**Re: Initial Submission Review – Green Valley Ranch East Site Plan No. 15 - Site Plan and Plat**  
Application Number: **DA-1662-26**  
Case Number(s): 2022-4014-00; 2022-3019-00

On behalf of Oakwood Homes, Aztec Consultants, Dewberry Engineering and Terracina Design, we have reviewed the comments dated March 24, 2022. The following is a response to comments.

TYPICAL CARRIAGE HOUSE POD SETBACKS

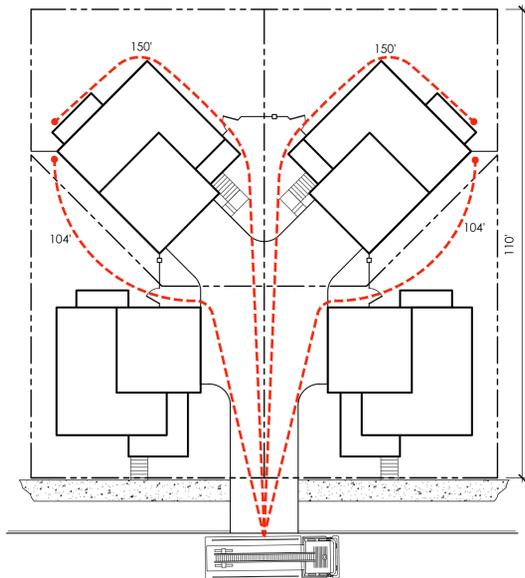
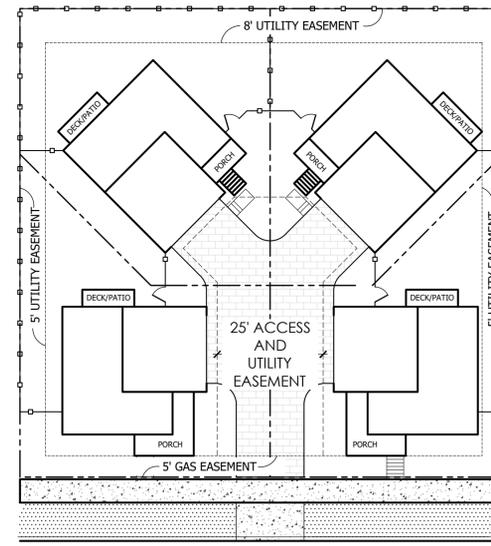
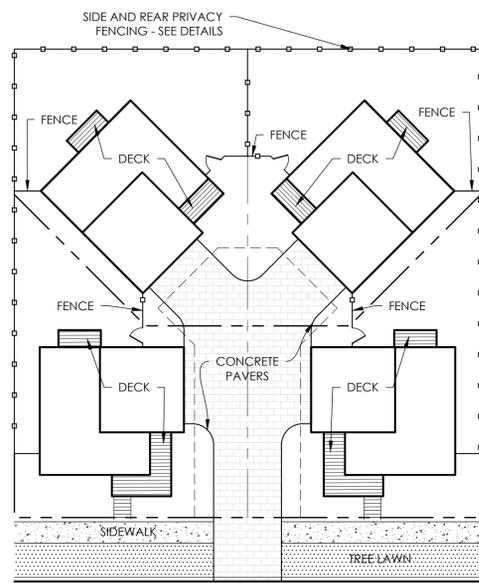
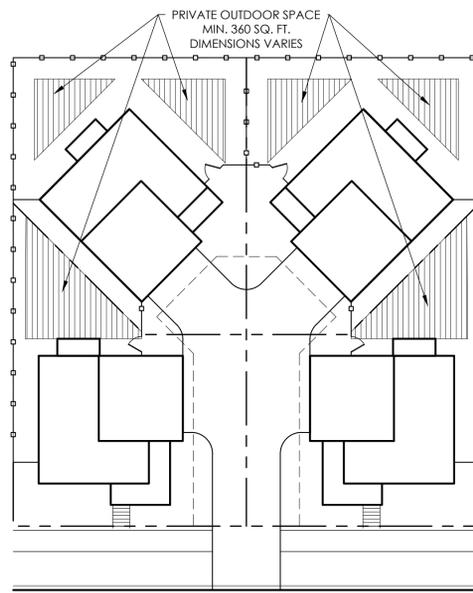
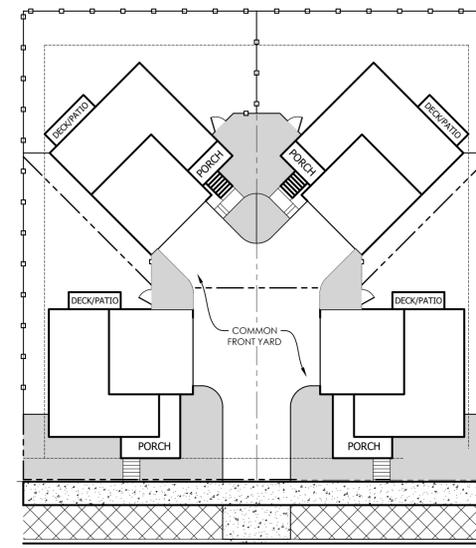
MOVE LOT TYPICALS TO THE FRONT OF THE PLAN SET  
Revised

SHEET 16 OF 36

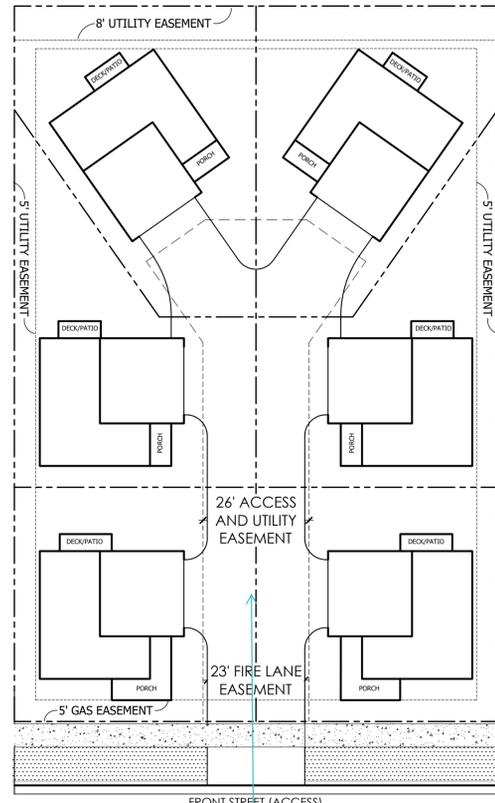
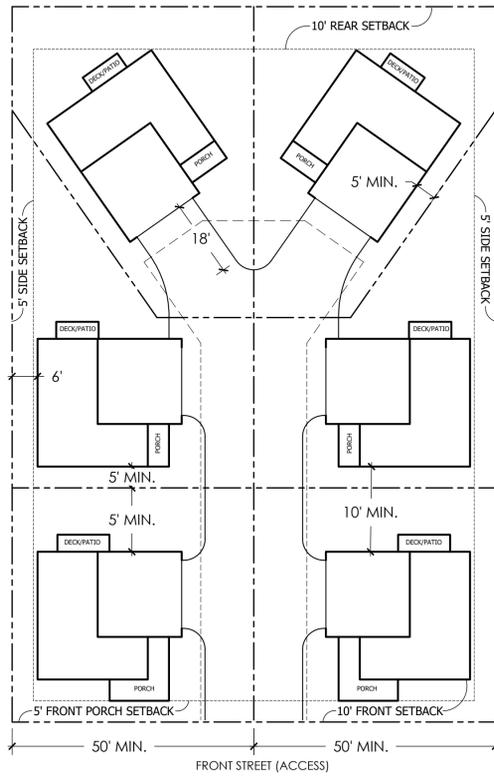
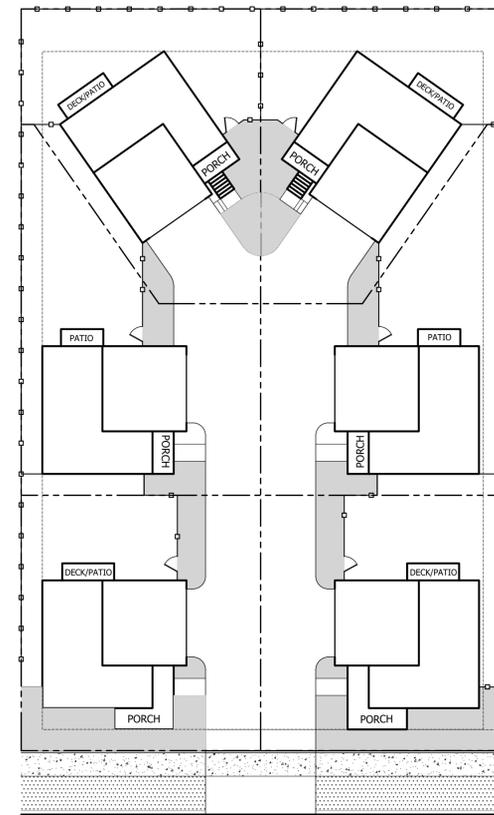
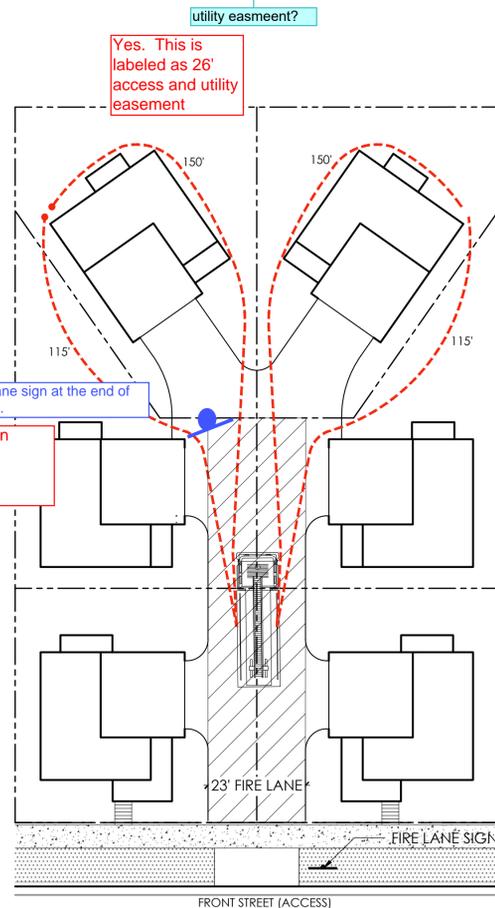
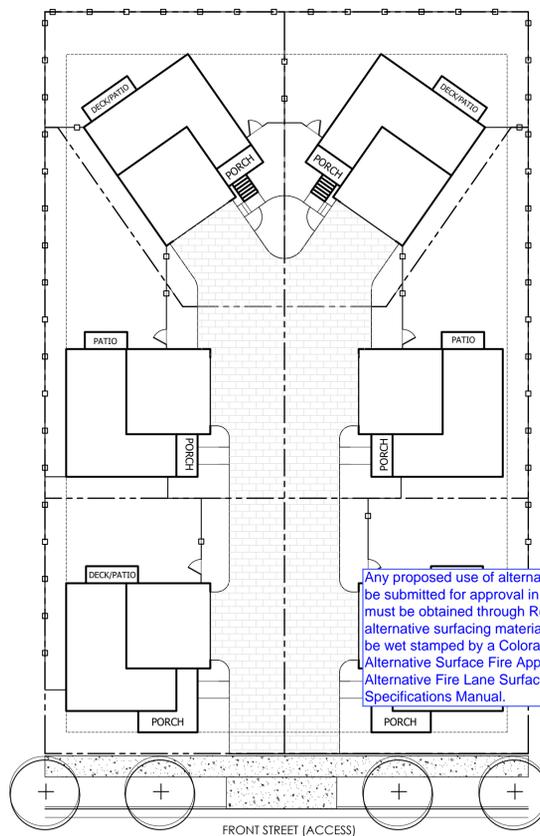
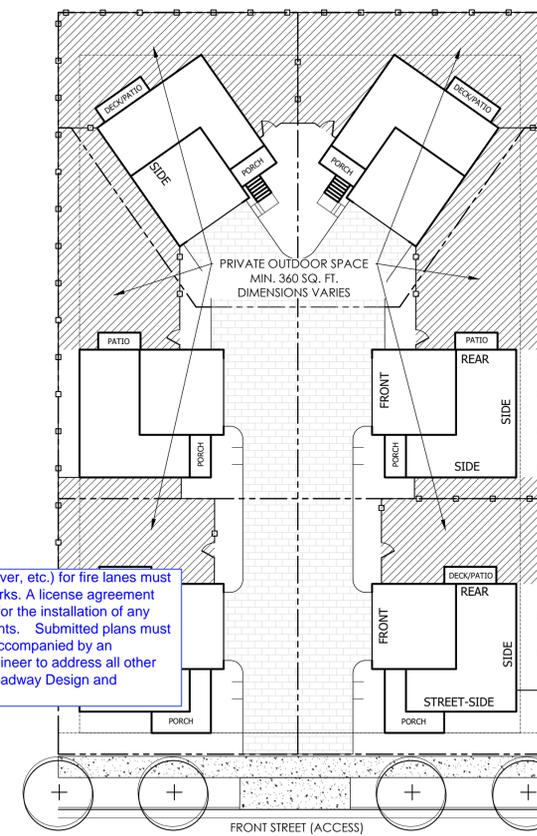
Included in license agreement  
 Any proposed use of alternative surfacing materials (e.g. concrete paver, etc.) for fire lanes must be submitted for approval in writing to the City Engineer of Public Works. A license agreement must be obtained through Real Property (Public Works Department) for the installation of any alternative surfacing material used within dedicated fire lane easements. Submitted plans must be wet stamped by a Colorado licensed Professional Engineer and accompanied by an Alternative Surface Fire Apparatus report. Please work with City Engineer to address all other Specifications Manual.

SHEET 19 OF 36

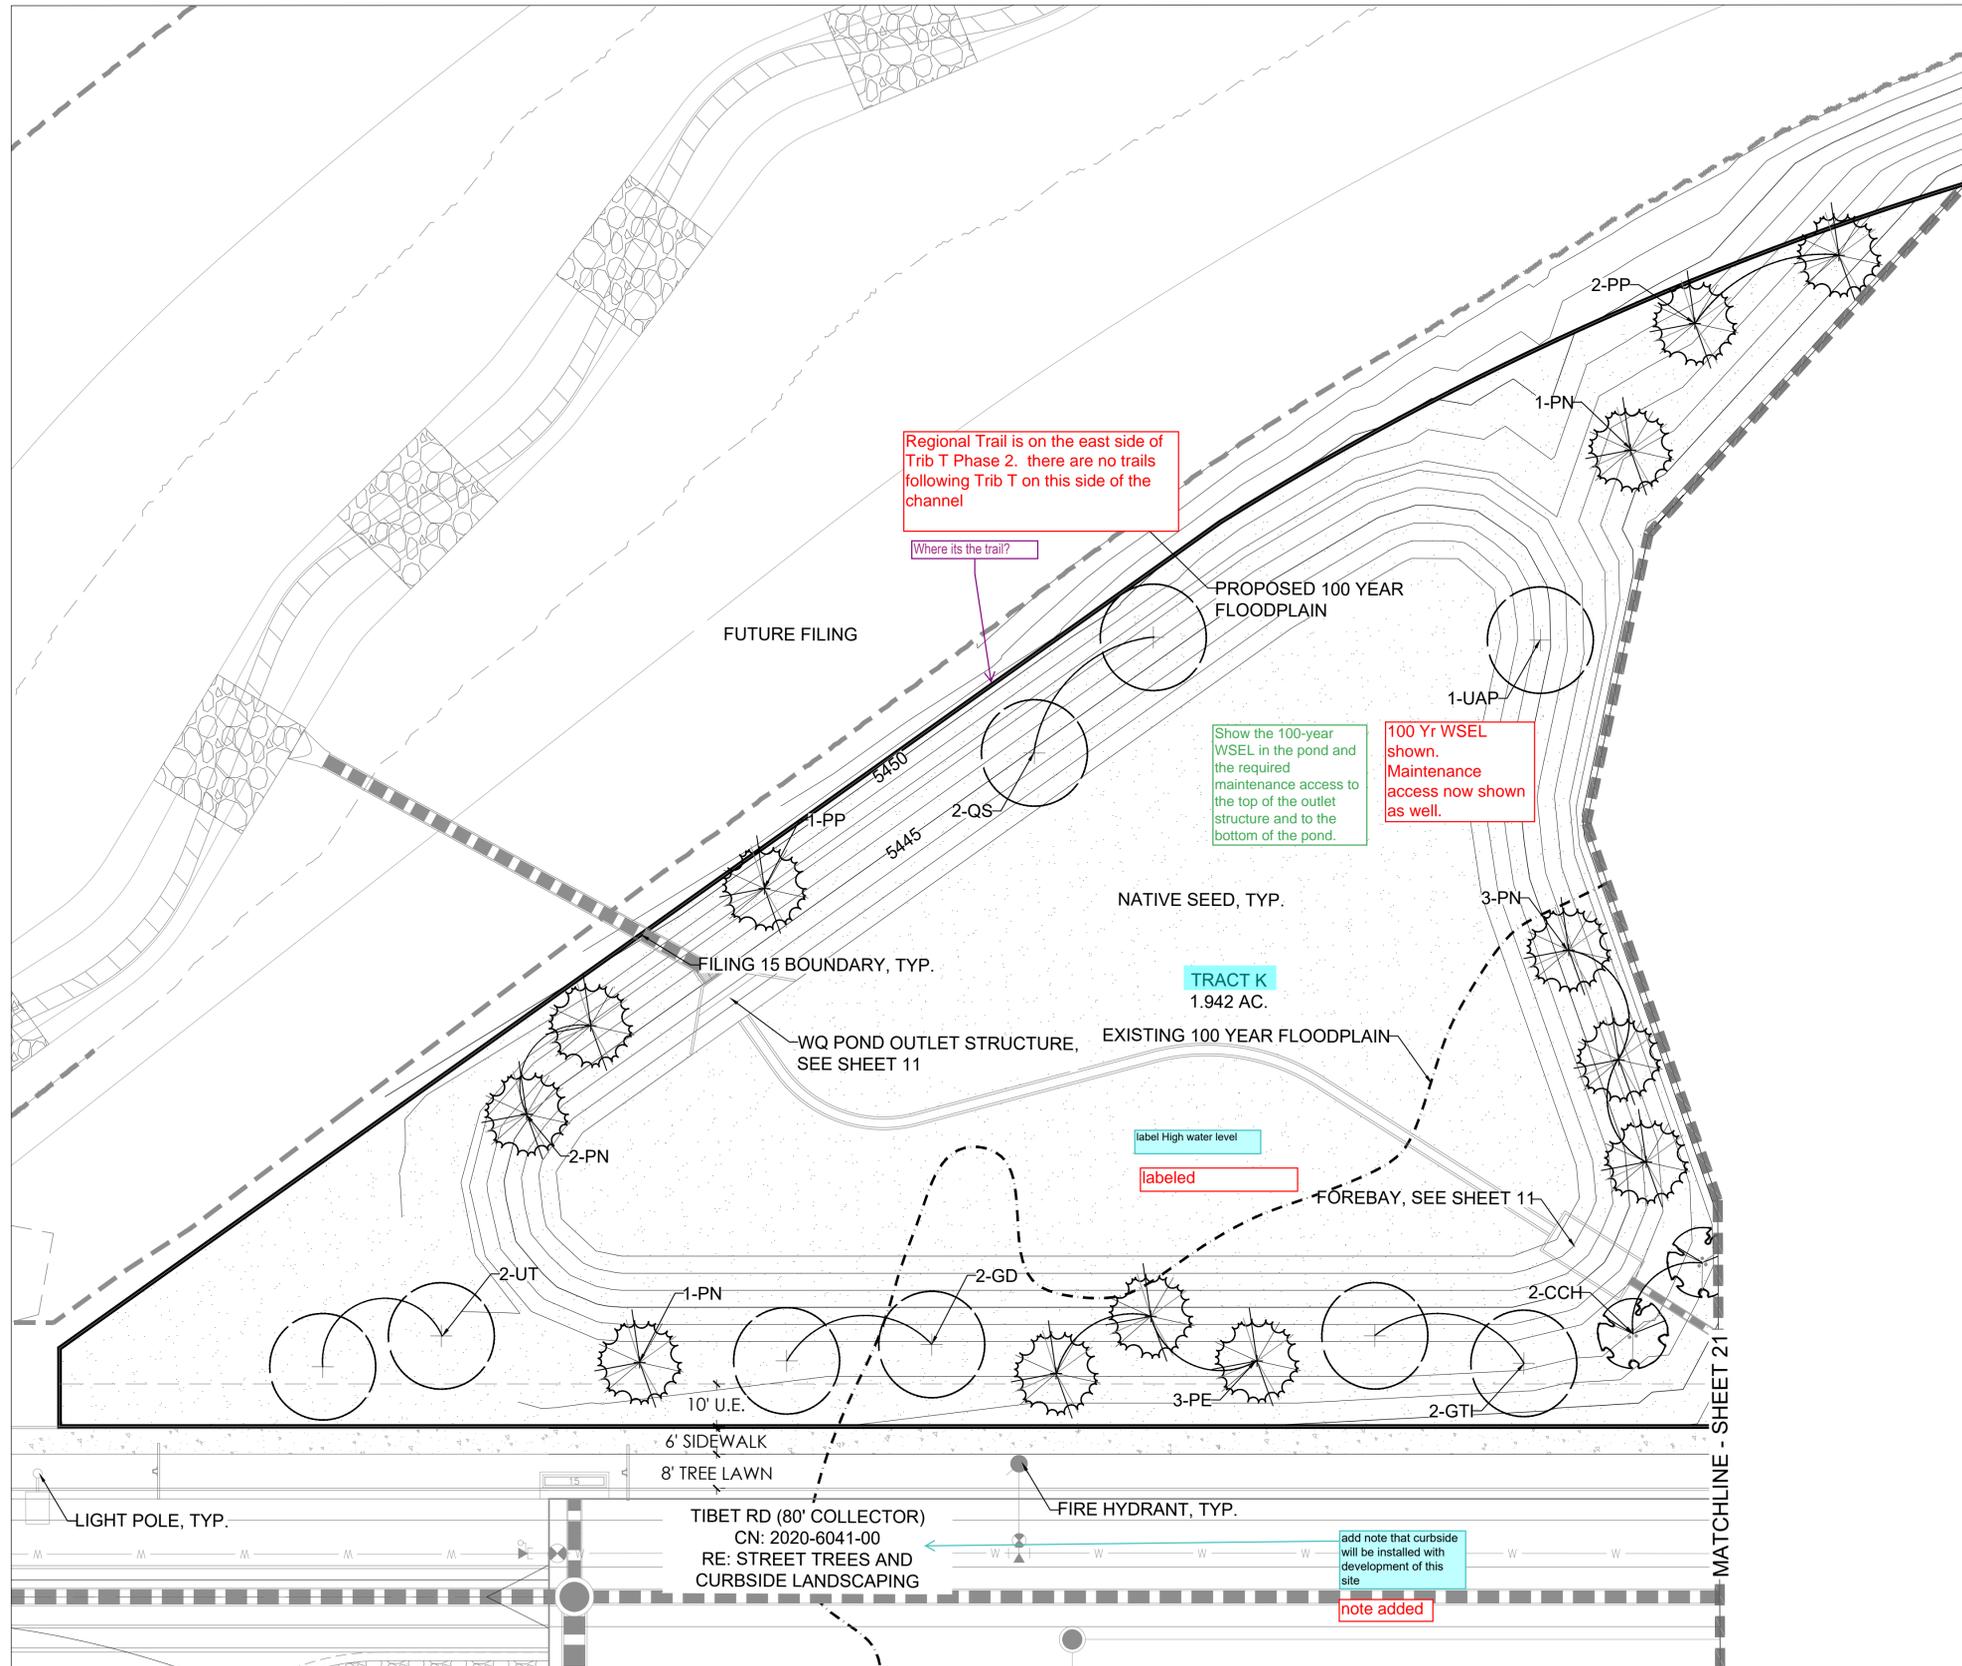
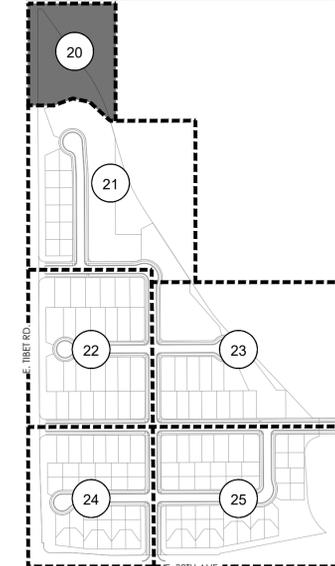
Show the 100-year WSEL in the pond and the required maintenance access to the top of the outlet structure and to the bottom of the pond.

label High water level

add note that curbside will be installed with development of this site  
note added

labeled
